UNITED STATES PATENT AND TRADEMARK OFFICE

APPLICATION NO.	FILING DATE	FIRST NAMED INVENTOR	ATTORNEY DOCKET NO.	CONFIRMATION NO.
10/051,327	01/22/2002	Mary L. Bussler	0981/1	2715

Office Action Summary

DETAILED ACTION

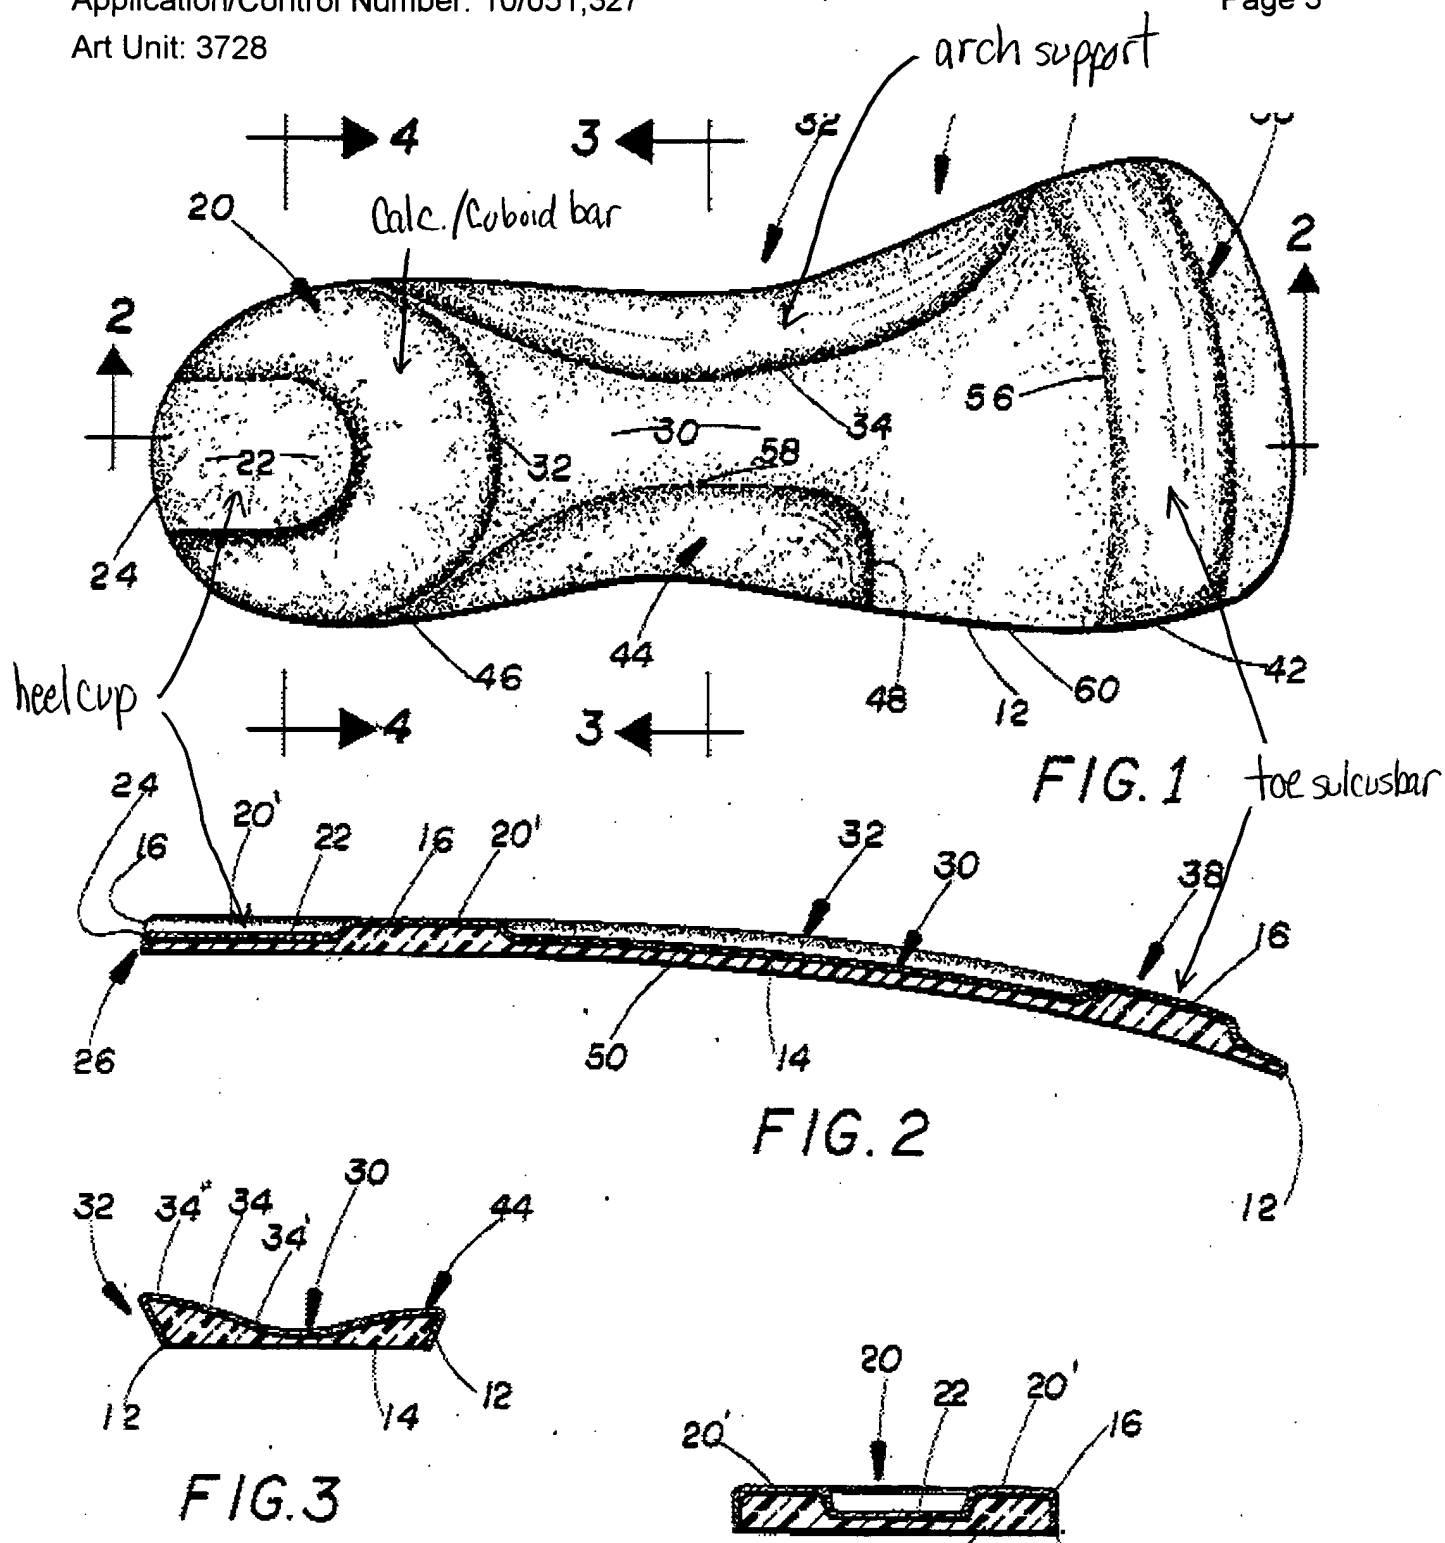
3. Claims 10,15-19,24-28,30 are rejected under 35 U.S.C. 102(b) as anticipated by or, in the alternative, under 35 U.S.C. 103(a) as obvious over US 4955148 (Padilla).

Padilla teaches the combination of a high-heeled shoe (see col. 1, lines 12-25) and a footbed (foot support assembly) as claimed, see the marked-up figures below. The foot support provides proper fitting within a give shoe style, see col. 2, lines 5+.

Padilla doesn't show the high-heeled shoe (otherwise known as pump shoes) but it is well known in the art for them to have an upper, a toe box and a heel having a height of at least 1 inch, and some being more than 3 inches. To the extent that Padilla doesn't teach a high-heeled shoe as claimed, the examiner takes official notice that high-heeled shoes having a toe box and heels of such height are well known and conventional in the art. Therefore, it would have been obvious to provide the shoe of Padilla with a high-heeled shoe, to provide proper support and balance to high-heeled shoes.
